Test Bench Foam Definition

GRSP Informal Group CRS Testing
8th meeting at BAST in Cologne
January 21, 2009

Prepared by: Kees Waagmeester

GRSP IG CRS 06-02:

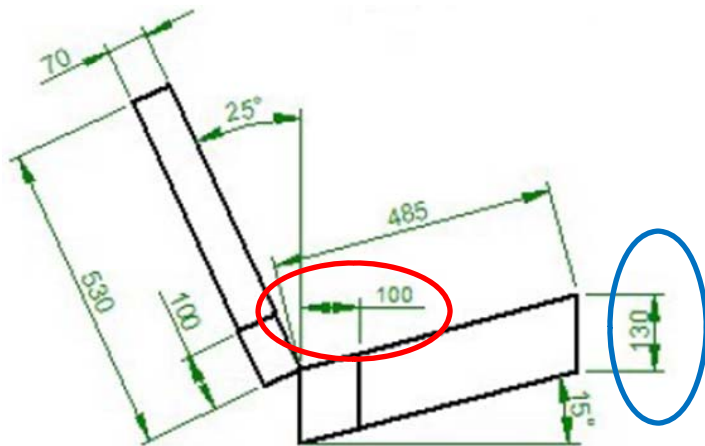
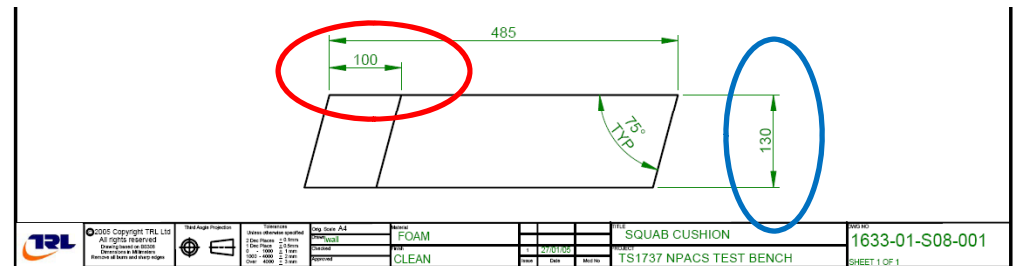
Questions that arose are:

GRSP CRS-06-02	NPACS Drawings
Squab thickness	125.6	130.0 (?)
Squab recess depth	100.0	96.6 (?)
Backrest height	530.0	590.0 (?)
Foam width at R-point	220.0	250.0 (?)

TRL promised to provide clarification.

Figure 1 – Headform drop test diagram.

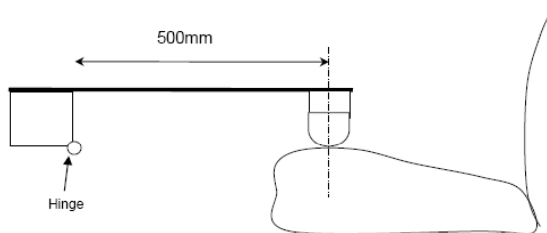
Questions that arose:

- Are the peak results presented in NPACS research average values of three tests per bench?
- What is the time history of the results?
 - Does bottoming out occur?
 - What are the penetrations recorded?
- The UNECE R44 test set-up is not described.
 - What kind of set-ups are used?
- What are acceptable tolerances on drop test results?
